APPLICATION NO.	FILING DATE	FIRST NAMED INVENTOR	ATTORNEY DOCKET NO.	CONFIRMATION NO.
10/651,047	08/29/2003	Teruaki Itoh	160-389	8529
23117	7590	04/05/2005	EXAMINER	
NIXON & VANDERHYE, PC 1100 N GLEBE ROAD 8TH FLOOR ARLINGTON, VA 22201-4714				CHIN, PAUL T
			ART UNIT	PAPER NUMBER
			3652

Office Action Summary	Application No.	Applicant(s)
	10/651,047	ITOH, TERUAKI
	Examiner	Art Unit
	PAUL T. CHIN	3652

DETAILED ACTION

FIG. 1

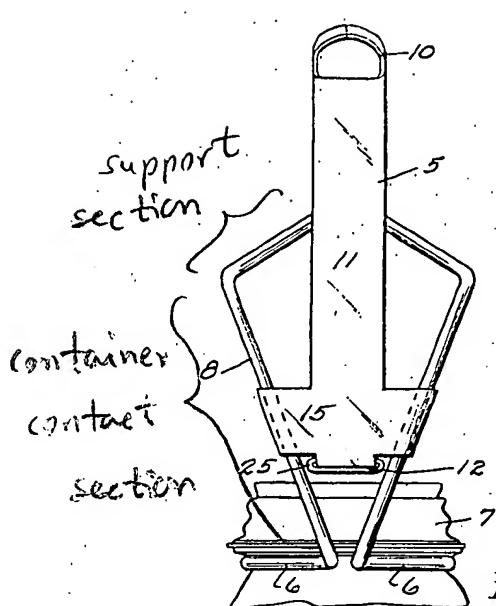
Eckert (2,115,015) discloses a container gripping device (see Exhibit A), comprising vertical and narrower strips (11,11) and spring coils (14), which can be considered as an open/close driver, a pair of opposed holding members (8,8) (Figs. 1,2, and 4) being formed of a substantially bent member portion and a substantially linear member portion, the member being made of strong wire (lines 28-31 of page 1), which is a metal wire, each holding member having (i) a pair of support sections (upper section of member 8), one end being coupled to the driver (see Fig. 4), (ii) a pair of container contact sections (lower portion of the holding member 8) which are connected at one end to the support sections, extending along a lengthwise direction of the container and biased toward the container, and (iii) a coupling section (6,6) (Fig. 5) or strong wires which couples other ends of the container contact sections and are curved so as to surround the outer surface of the container with a gap there between (see Fig. 1).

FIG. 3

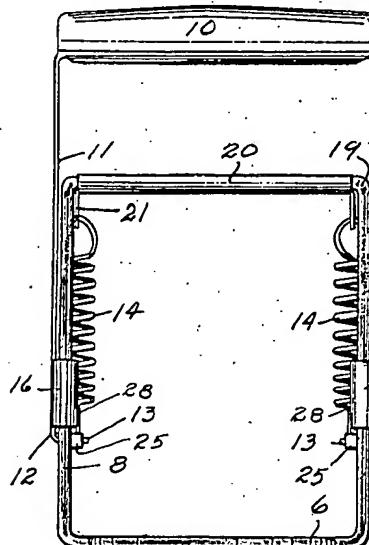
Re claim 10, a u-shape holding member (8,8) is clearly shown in figure 3.

U-shaped holding member
(8,8)

FIG. 6

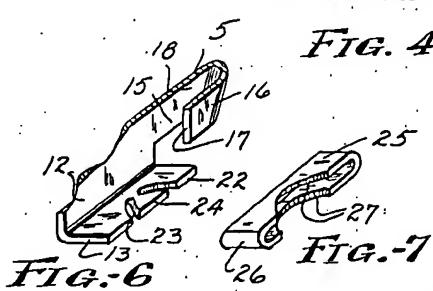
coupling section

Exhibit B

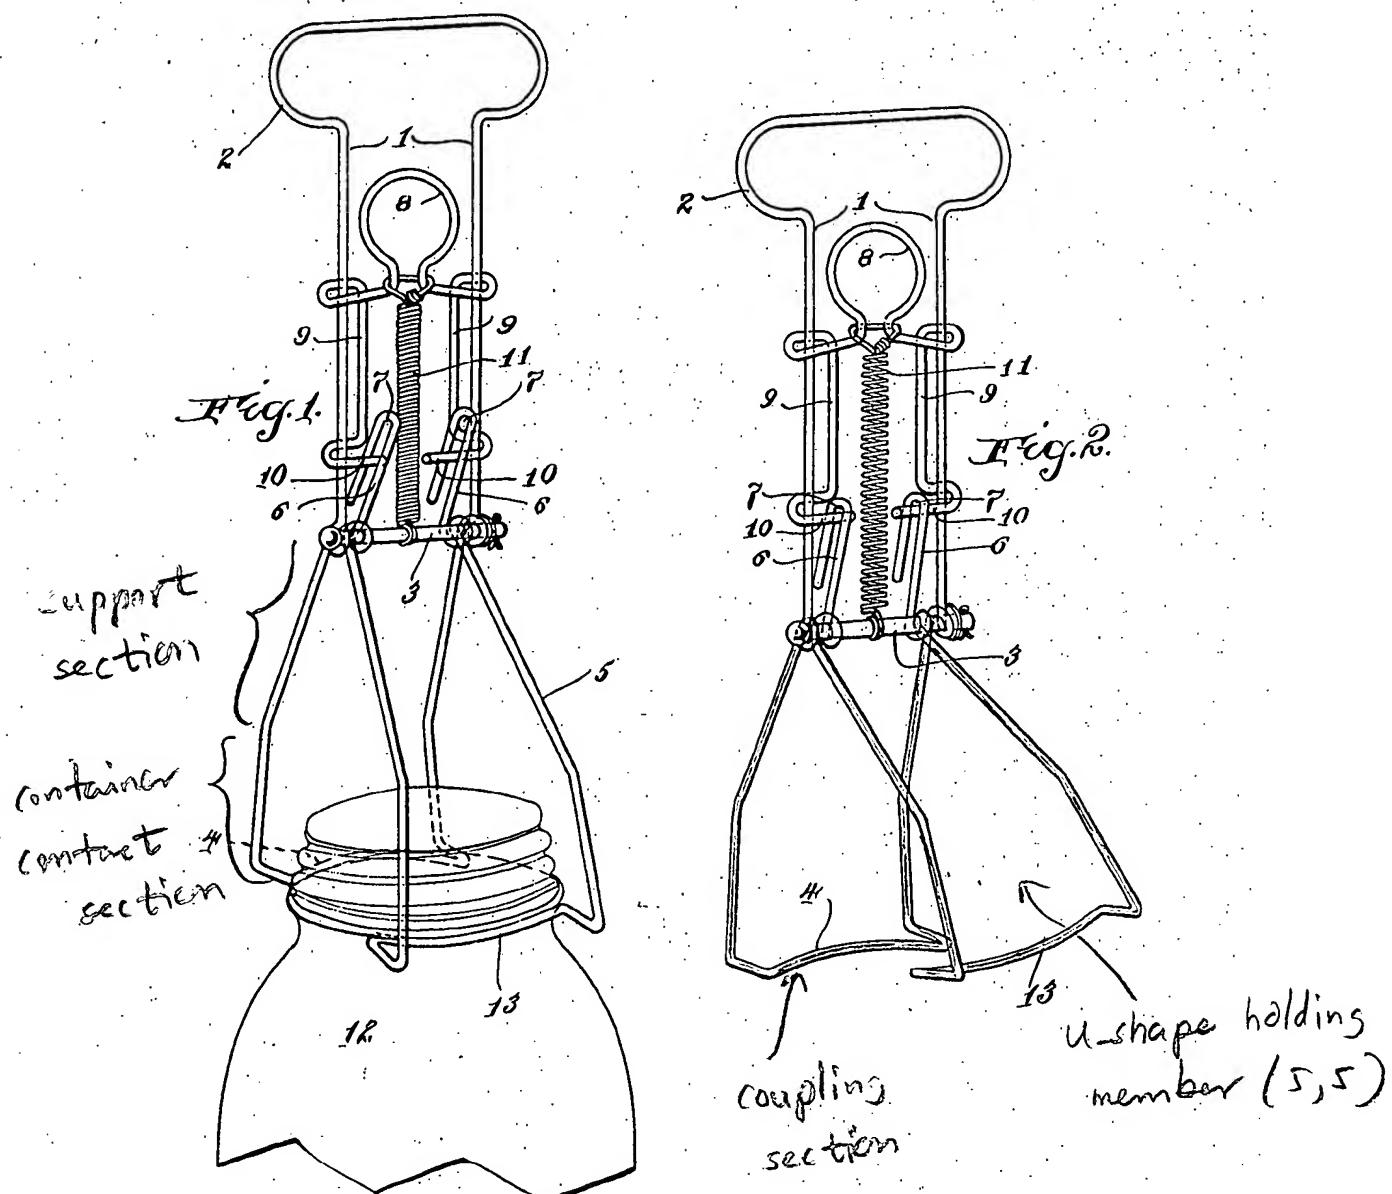
Lehr, Sr. (1,631,598) discloses a container gripping device (see Exhibit B), comprising vertical and constraint members (1,2,8,9) and a spring (11), which can be considered as an open/close driver, a pair of opposed holding members (5,5) being formed of a substantially bent member portion and a substantially linear member portion, the member being made of a wire (lines 18-21 of page 1), each holding member having (i) a pair of parallel support sections (Fig. 2), one end being coupled to the driver, (ii) a pair of container contact sections (lower portion of the holding member 5) which are connected at one end to the support sections, extending along a lengthwise direction of the container and biased toward the container, and (iii) a coupling section (4,13) (Fig. 2) which couples other ends of the container contact sections and are curved so as to surround the outer surface of the container with a gap there between (see Fig. 1).

Re claim 10, a u-shape holding member (5,5) is clearly shown in figure 2.
